CLIVE PLANNING & ZONING COMMISSION

RE: Site Plan Amendment - 1229 NW 86th St - Discount Tire

Re: 1229 NW 86TH ST - Discount Tire Building Addition - Site Plan Amendment

TENANT IMPROVEMENT - EXPANSION

SITE PLAN

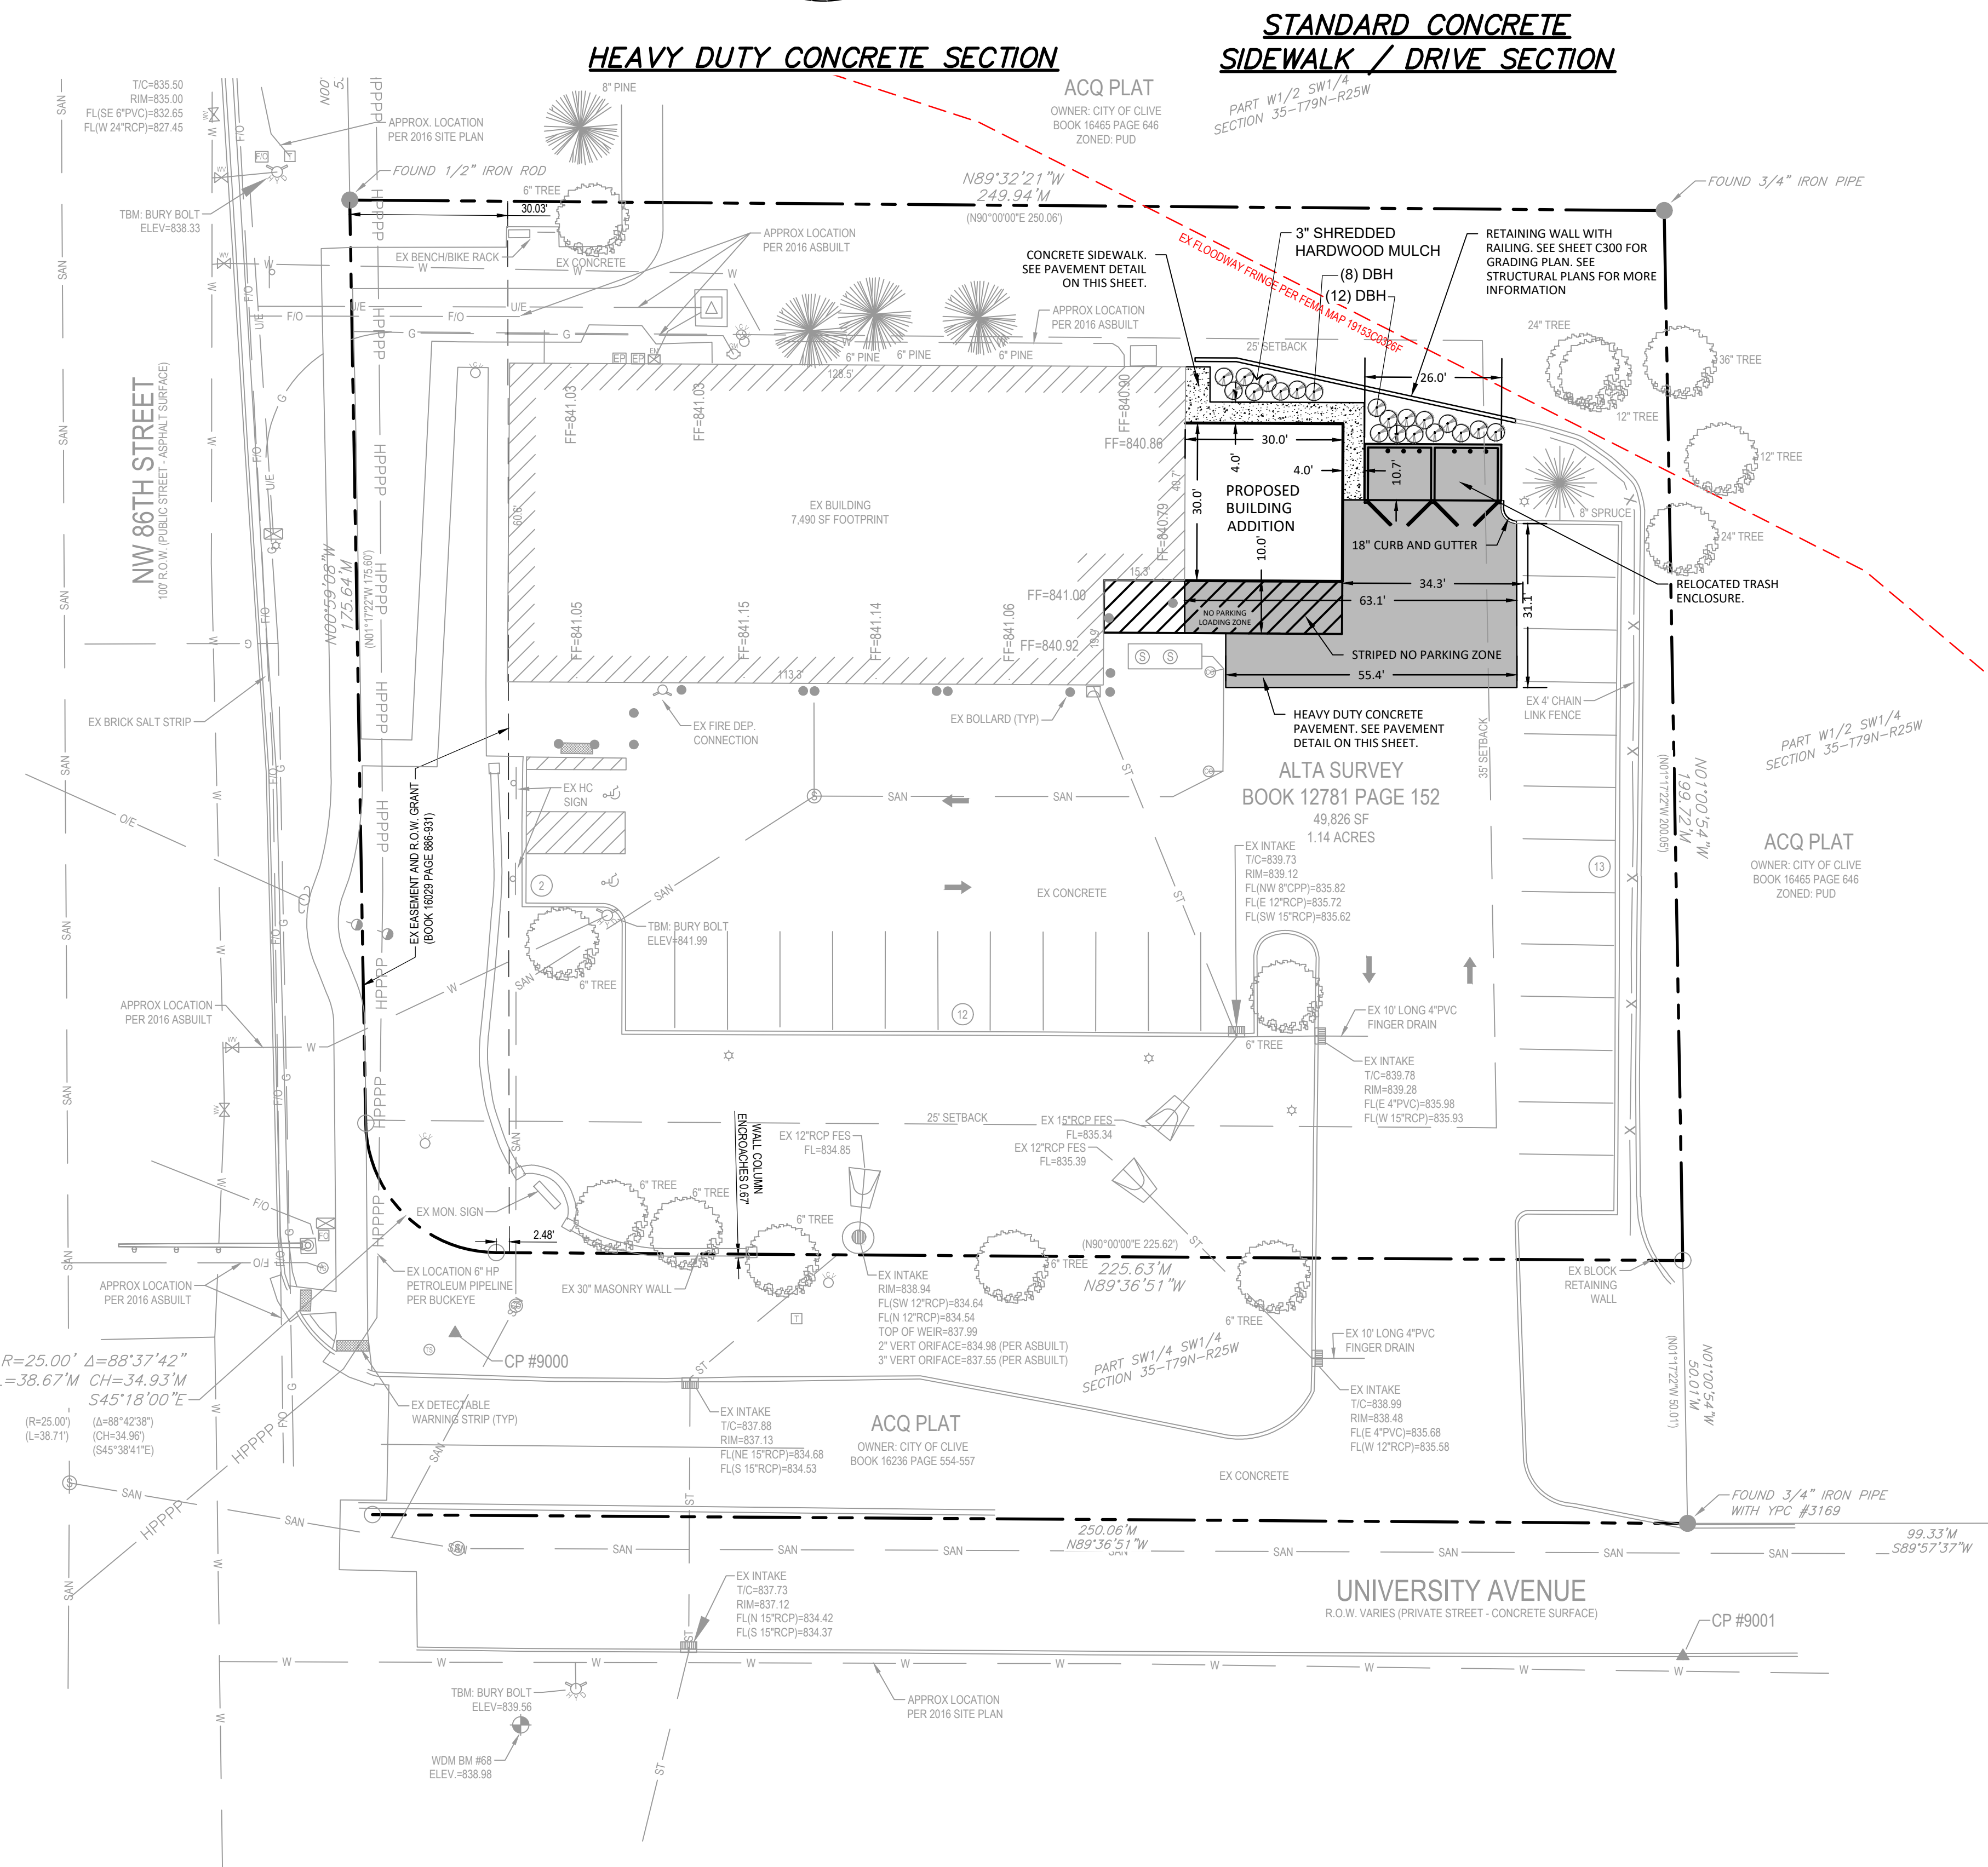
1. C200: Please provide the existing floodway fringe boundary to ensure the replaced retaining wall is outside of the floodway.
[This is now shown on all civil sheets in red.](#)
2. A retaining wall detail is required. Per the City's Development Standards Manual, retaining walls that are not laterally supported at the top and that retain in excess of 48" of unbalanced fill shall be designed in accordance with accepted engineering practices to ensure stability against overturning, sliding, excessive foundation pressure and water uplift. Retaining walls shall be designed for a safety factor of 1.5 against lateral sliding and overturning.
[This note was added to C200](#)

4. Please show the floodway fringe line on the new site plan relative to the placement of the addition and retaining wall.
[This is now shown on all civil sheets in red.](#)
